# TECHNICAL NOTE

from:	ALAN DAVIES	date:	7/12/2020
subject:	<b>PROPOSED RESIDENTIAL DEVELOPMENT HIGH MOOR CLITHEROE</b>	file ref:	J1002-TN1

This Technical Note sets out the response to the highway feedback.

**The proposed improvement to the A671 Waterloo Road / Shawbridge Street mini roundabout is shown overleaf.**

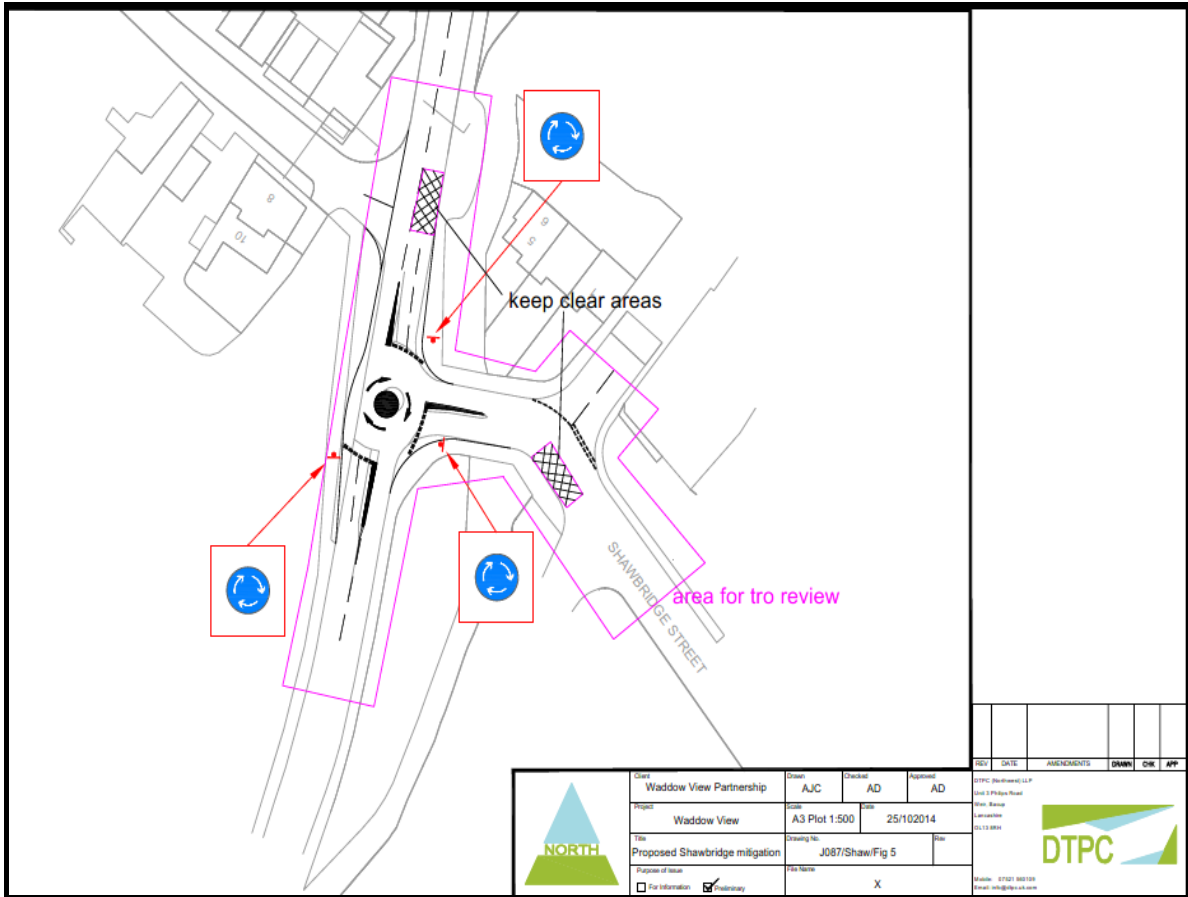
*LCC further requested using these figures can you assess the impact on the Waterloo Road / Shaw bridge Street junction.*

**The issue is that the committed development have agreed monies to be paid to improve this junction to support that developments however to date no approved scheme has been adopted.**

**Given this it has been agree with the Highway Authority to use the fallback improvement scheme at the junction for lane widening which will be tested with the proposed development flow in 2020 and 2030.**
